Minimum Bubble Point Specification for Sterilizing-Grade 0.22 µm Durapore® Membranes

Reference: Change in Durapore minimum bubble point specification

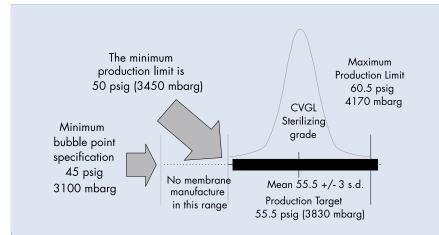
In evaluating the bubble point distribution for sterilizing-grade (0.22 µm) Durapore hydrophilic membrane, our data have shown that our process yields a mean bubble point value of 55.5 psig (3830 mbarg), and the minimum bubble point production limit is 50 psig (3450 mbarg). These data, which cover over 50,000 measurements, show that 99.9 % percent of membranes cast have a bubble point of greater than 50 psig (3450 mbarg).

To facilitate compliance with recent industry and regulatory initiatives in bacterial retention validation of sterilizing filtration, Millipore recommends the implementation of a minimum in-process bubble point specification of 50 psig (3450 mbarg). This bubble point specification is defined as the value at the low end of the filter membrane production limit. This value is the bubble point specification for all Durapore sterilizing grade membranes (figure 1). No filter device is released from manufacturing with bubble points below this value.

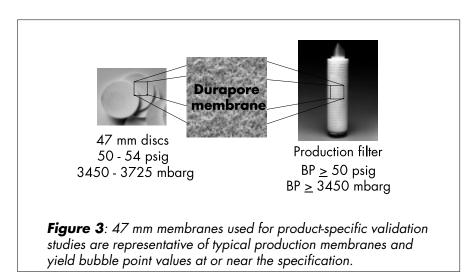
Membranes used for bacterial retention validation range between 50 and 54 psig (3450 and 3725 mbarg). In this sense, 50 to 54 psig (3450 to 3725 mbarg) can be said to be truly representative of low-end bubble point values from typical manufacturing, as this represents 13% of our membrane production. As such, these membranes are suitable candidates for bacterial retention validation (see figure 2).

Challenging membranes with bubble point values ranging from 50 to 54 psig (3450 to 3725 mbarg) during bacterial retention validation studies supports the use of an in process specification of 50 psig (3450 mbarg).
